# Service Bulletin

Bulletin No. 2016-71  
OEM No. 2016-71

# Mercury Diesel 3.0L Tier 3 Turbocharger Oil Supply Line Sealing Washers

Dot location

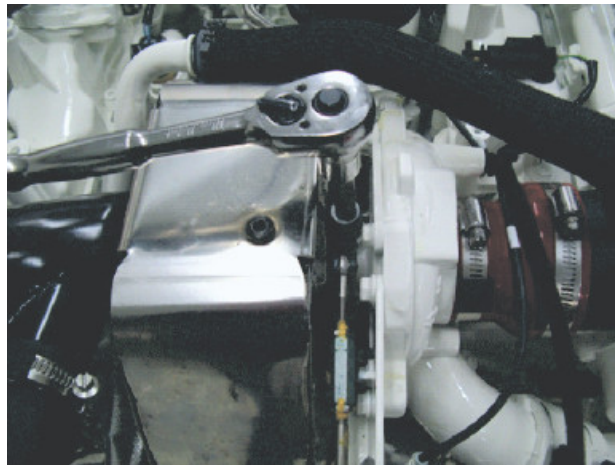
Engines reworked by the factory or by an authorized dealer will have a mark indicating that the rework has been performed. With the engine removed from the shipping container, or installed in a boat the rework identification will be a yellow dot placed to the left of the serial number decal.

**NOTE:** A green dot may also be found. The green dot indicates that the oil supply line has already been updated. If a green dot is not found, please refer to **Mercury Diesel Service Bulletin 2014-68**.

Oil supply line hollow bolt

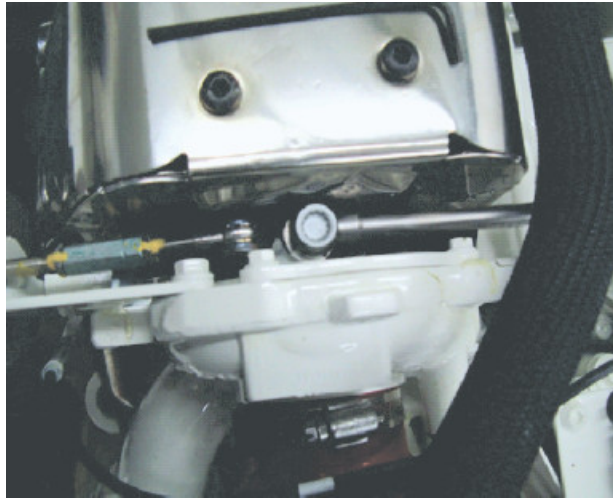
1. Remove the engine cover.
2. Remove the hollow bolt securing the oil supply line to the turbocharger.

3. Remove the sealing washers on each side of the hollow bolt fitting.

4. Install new sealing washers and tighten the hollow bolt finger-tight.

5. Tighten the hollow bolt to the specified torque.

Description	Nm	lb-in.	lb-ft
Hollow bolt	20	177	–
